LINCOLN/LANCASTER COUNTY PLANNING STAFF REPORT

for August 2, 2006 PLANNING COMMISSION MEETING

PROJECT #: Waiver of Subdivision Requirements #06007

PROPOSAL: To waive the requirements for sidewalks as per Section 26.27.020 of the Subdivision Ordinance.

Waiver #06007 **S 27th St & Pine Lake Rd**

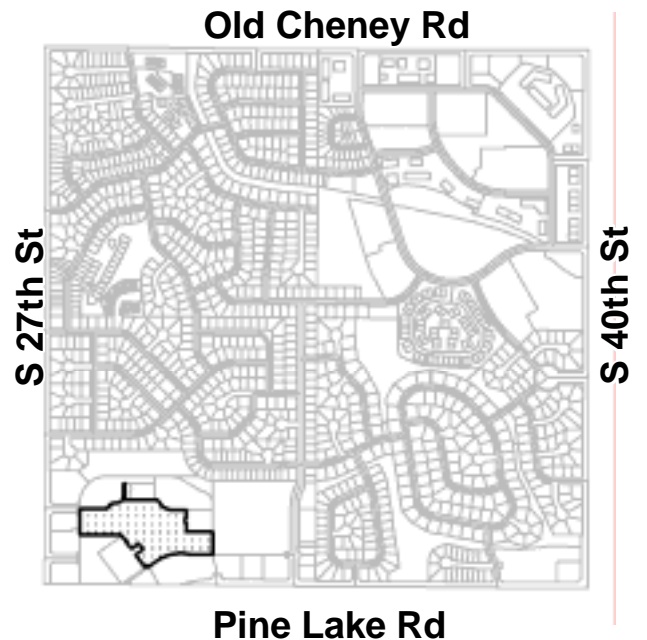
Area Concerning Waver

SITE PLAN

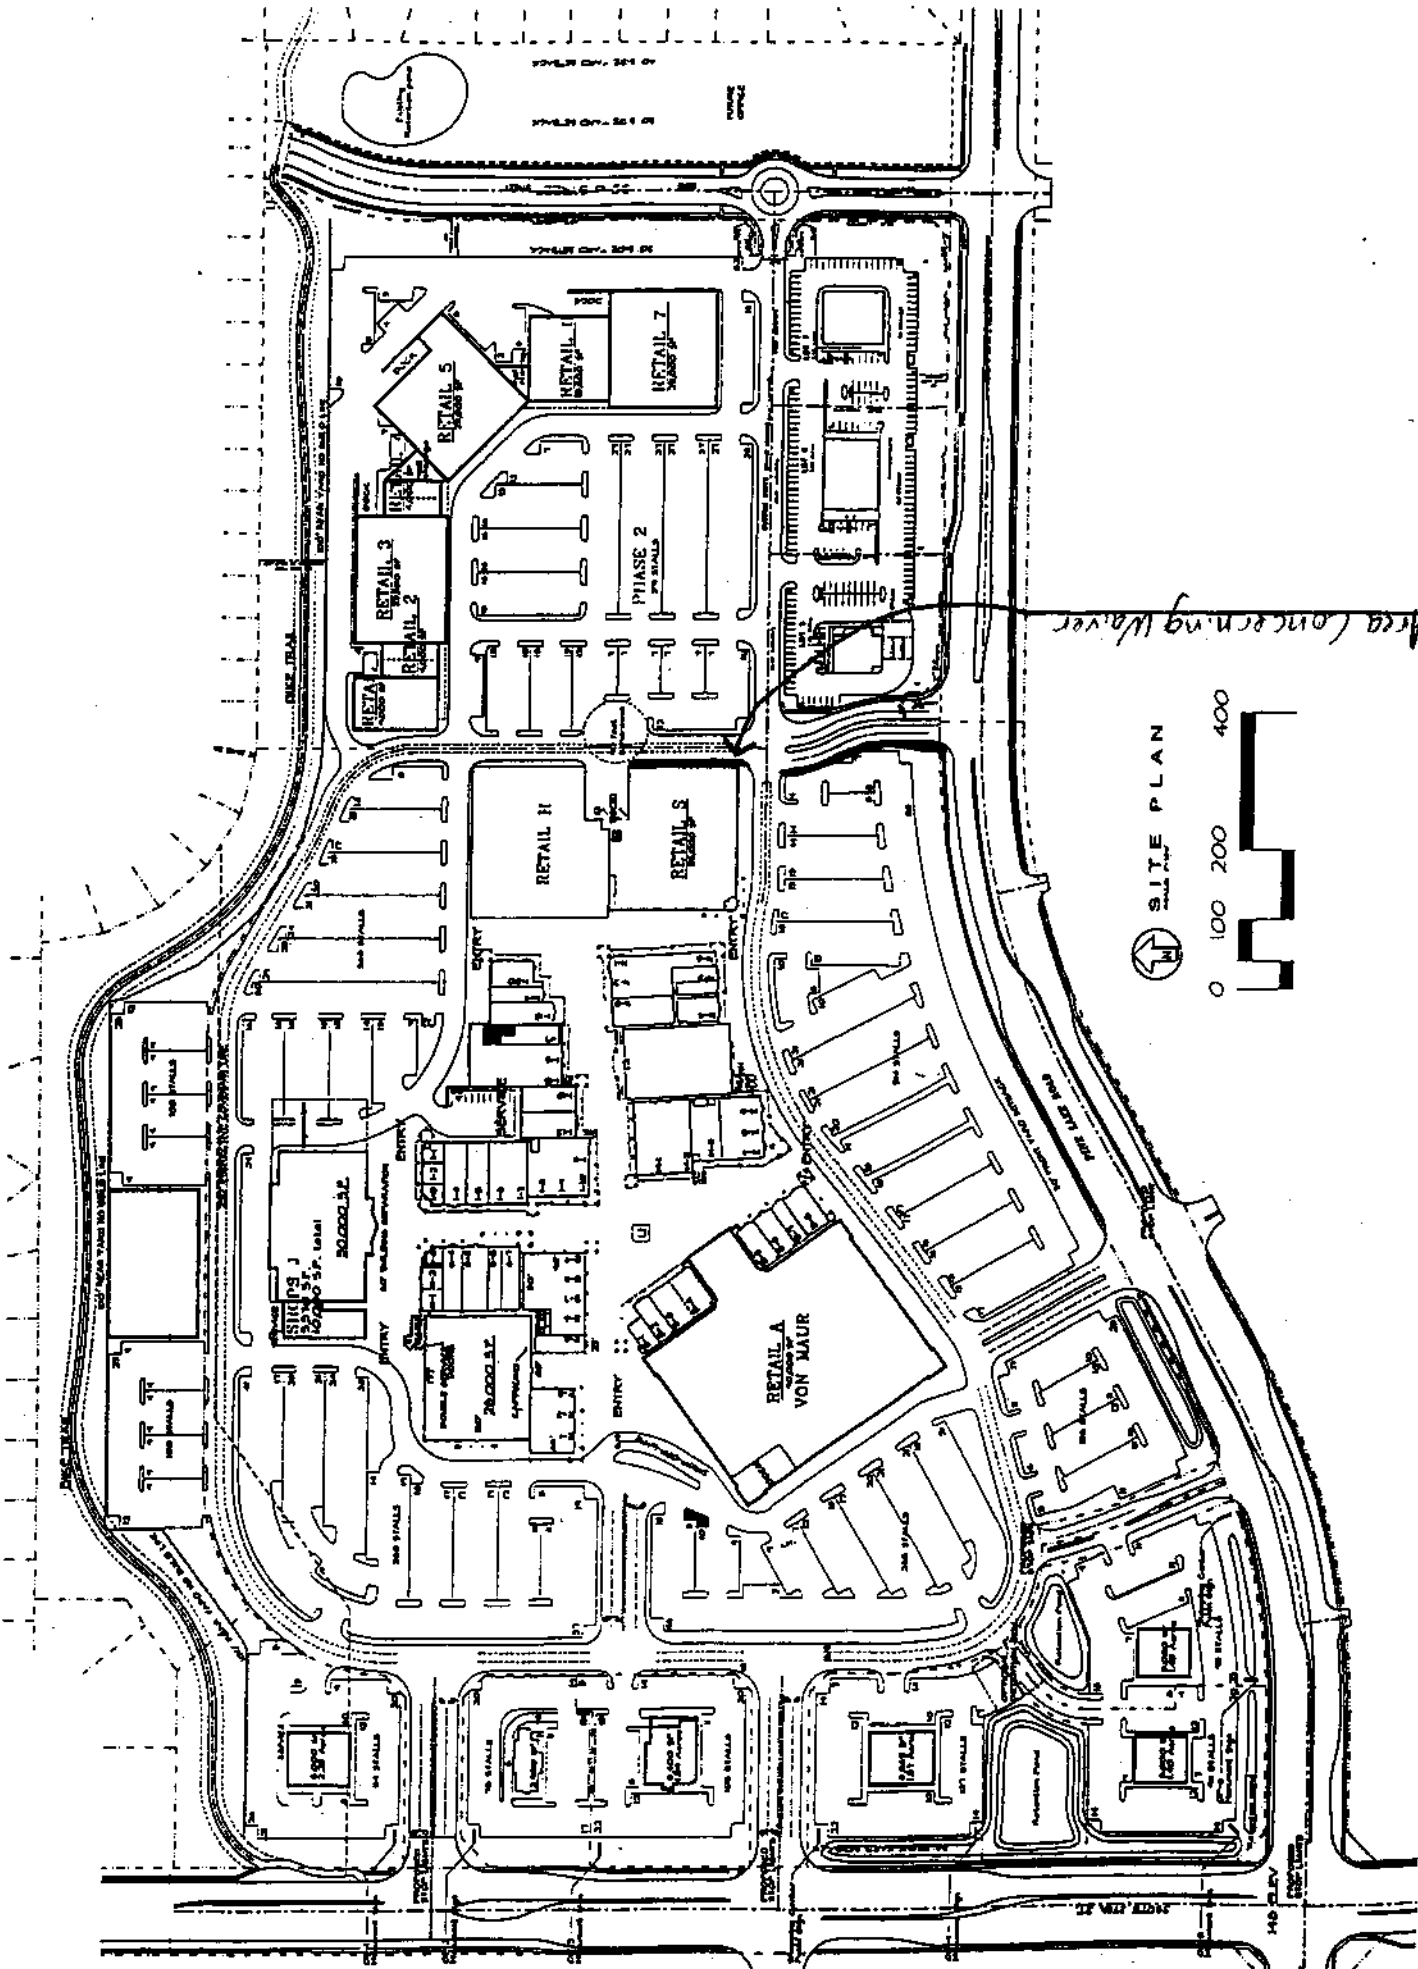
protection system) which would be a walkway hazard. Also, due to the location of the fire sprinkler drain all the water would drain onto the walkway during system maintenance which would be a hazard and there is an emergency exit door on this side of the building that would swing outward into a walkway creating another potential hazard. There is also a large gas meter on this side of the building.

This waiver request is for the west area next to the building of Bed Bath & Beyond which is pictured later below.

The existing pedestrian walkway runs from the South property line at Pine Lake Road through the entire property to the North property line where it links to the City Trail. Although the existing walkway links Pine Lake Road to the City Trail, this area sees very little foot traffic and the current pedestrian walkway provides more than adequate service for this area. The majority of the foot traffic enters the property at 27th Street and Ridgeline Road (by First National Bank). The following pictures show the existing walkway located on the East side of South 30th Street and the area regarding the waiver.
